# CITY OF ALBUQUERQUE

**RE: Westside Blvd. PH II  
Drainage Calculations  
Engineer's Stamp Date - no stamp (File: A12D024A)**

Re: Westside Boulevard PH II

# Storm Sewer Profile

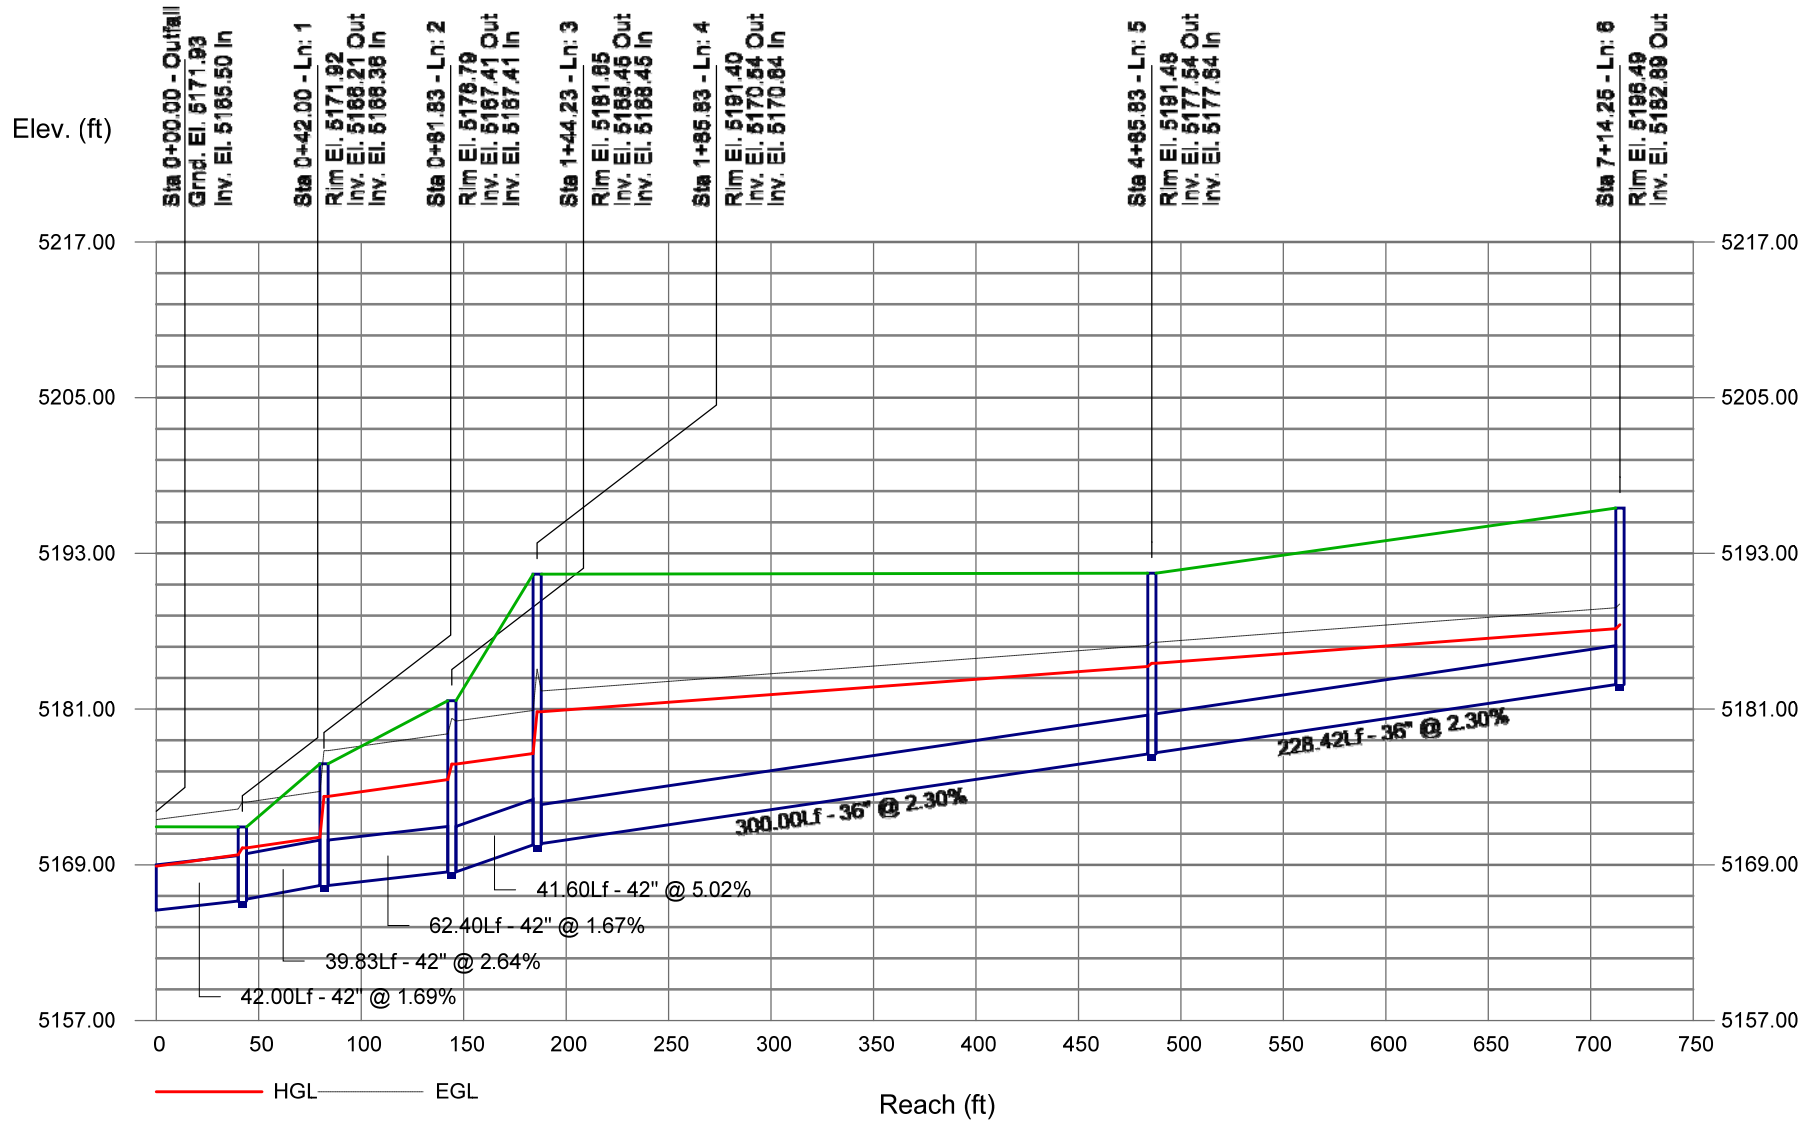
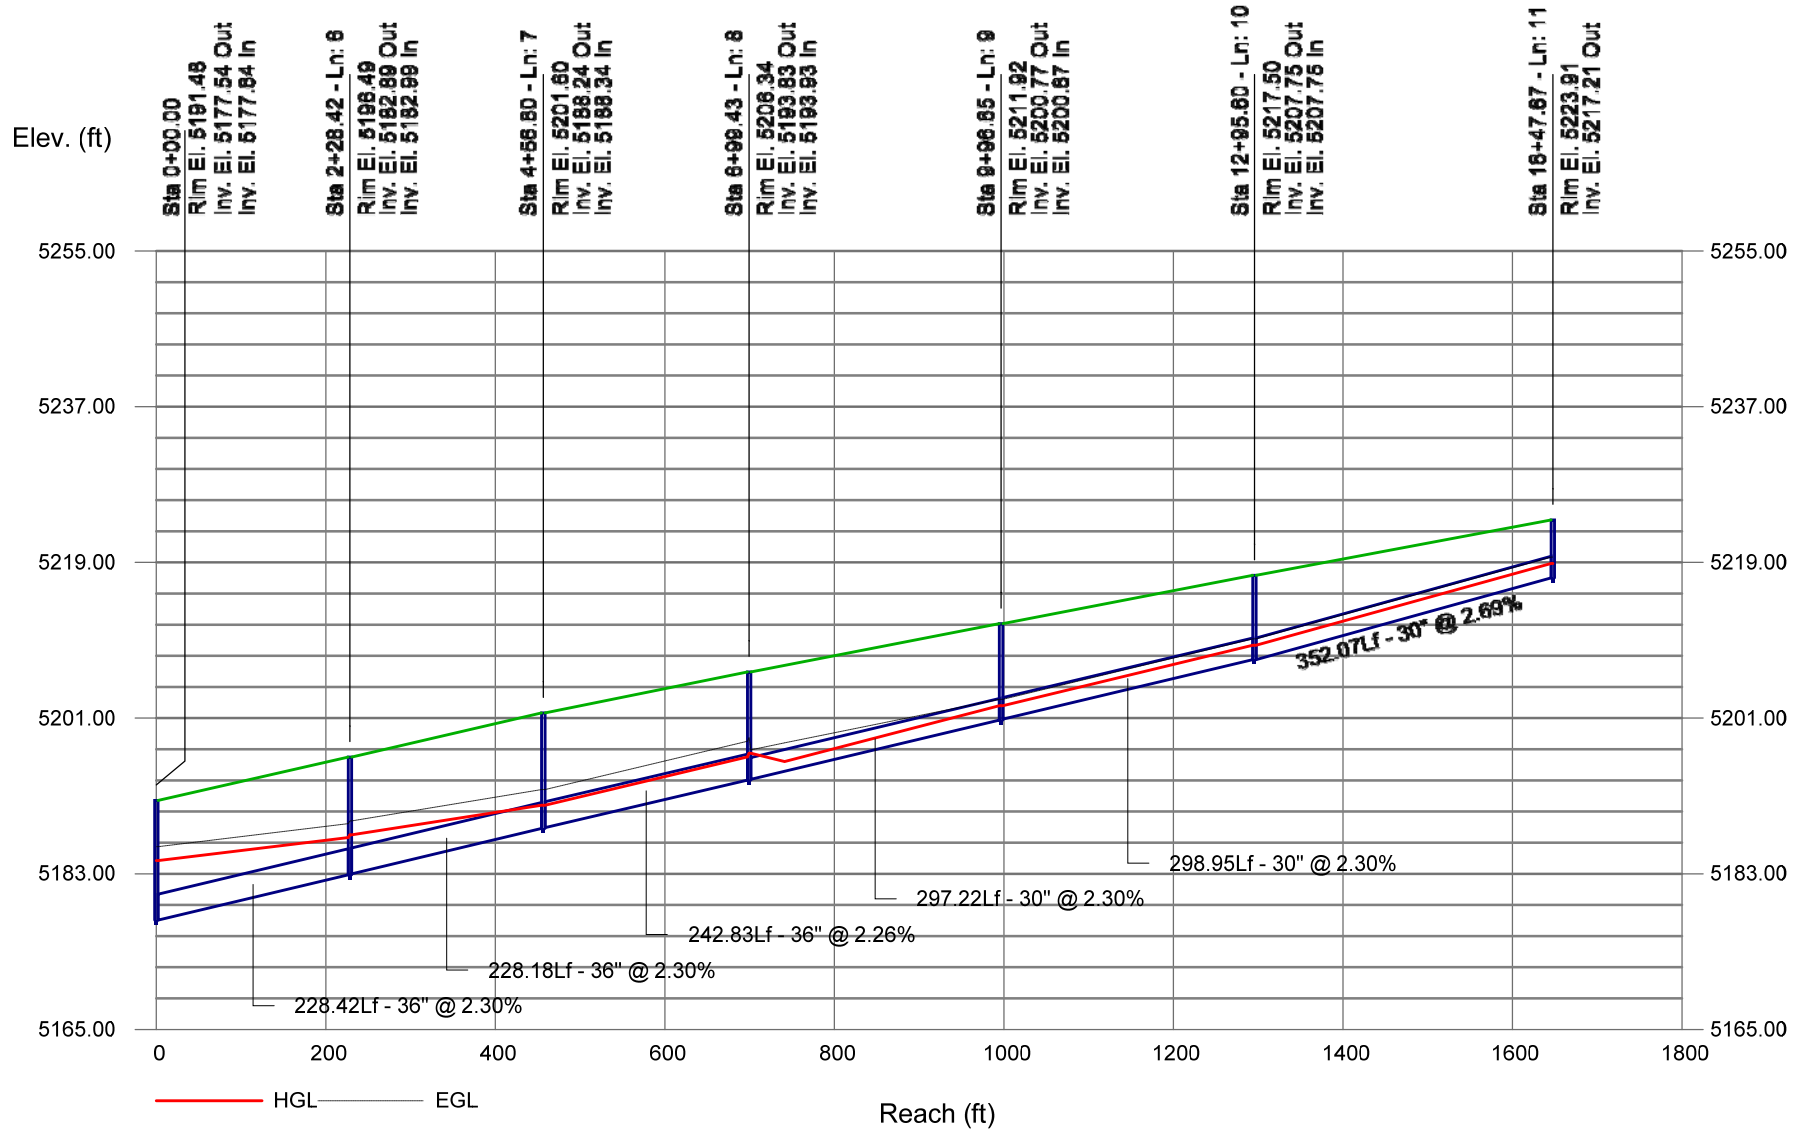
- The analysis of the Storm Drain (main trunk line) on the west side of the East Branch Channel uses flows shown on the As-Builts (Wilson & Co, October 2006, Westside Blvd.). However, per our conversation, it is not clear why the flow increases from 24 cfs to 72 cfs and then to 144 cfs, and there is not a report that explains the increase. Per our conversation, it may be that Basin 21 from the Cabazon Communities Phase 2 Drainage Management Plan, Unit 16 (Aug. 2004, Wilson & Co.) was intended to discharge 62 cfs to the Storm Drain rather than the channel (See Figure 6) but the As-Builts do not show any connections to that basin.
- Since there was not a clear explanation for the discrepancy, Wilson & Co. has decided to conservatively rely on the As-Built information for the hydraulics.
